DEVELOPMENT APPLICATION ASSESSMENT REPORT

Application Number:	DA2023/0614
----------------------------	-------------

Responsible Officer:	Thomas Prosser
Land to be developed (Address):	Lot 4 DP 835792, 61 Darley Street MONA VALE NSW 2103
Proposed Development:	Demolition works and construction of a car showroom
Zoning:	E4 General Industrial
Development Permissible:	Yes
Existing Use Rights:	No
Consent Authority:	Northern Beaches Council
Land and Environment Court Action:	No
Owner:	AMG Headquarters Six Pty Ltd
Applicant:	Williams River Steel Pty Ltd

Figure 1: Representation of height blanket provided by applicant (and confirmed as accurate through assessment of architectural plans and survey)

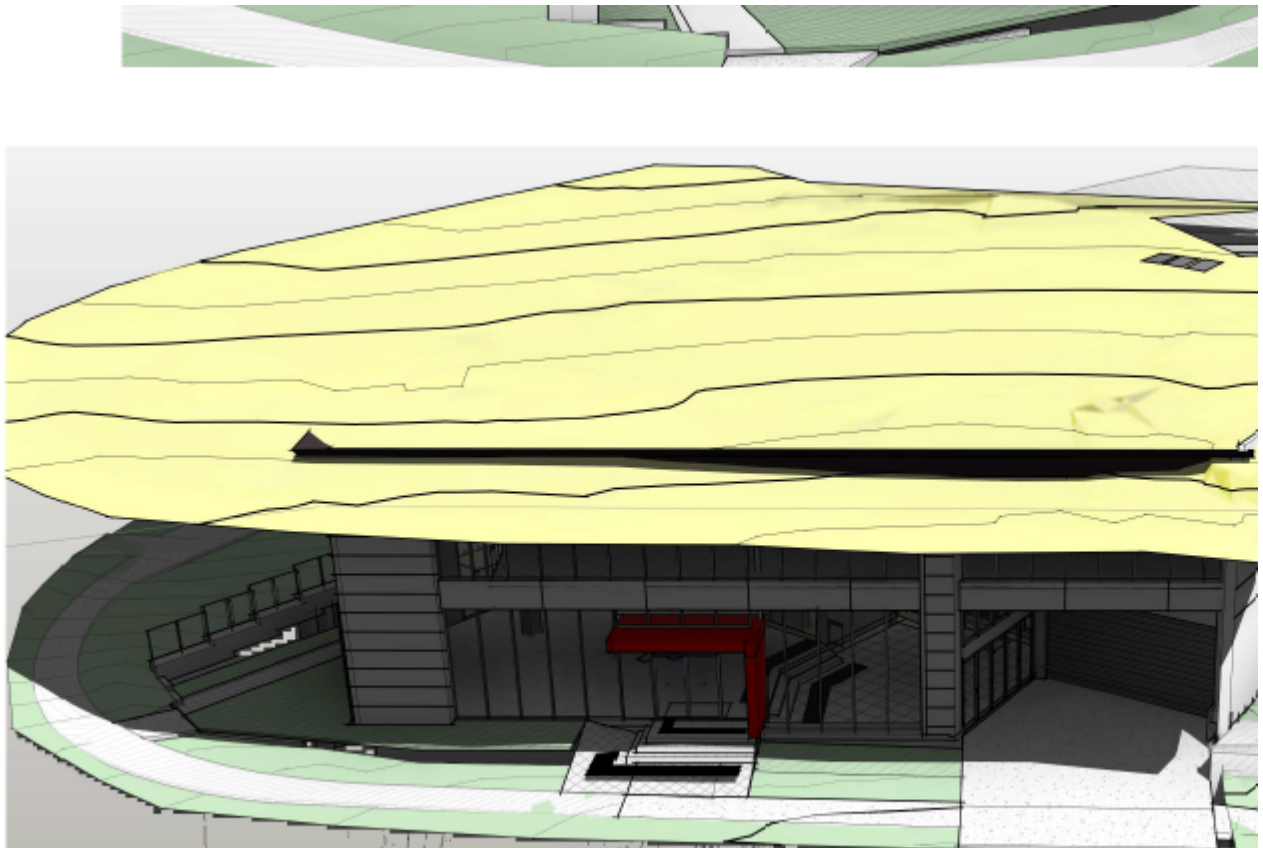
Development standard:	Height of buildings
Requirement:	8.5m
Proposed:	9m
Percentage variation to requirement:	5.5%

The following diagrams provide a representation of the height non-compliance:

It is agreed that the non-compliance occurs as a result of slope and a need to provide suitable access. It is also agreed that any adverse impact is appropriately avoided.
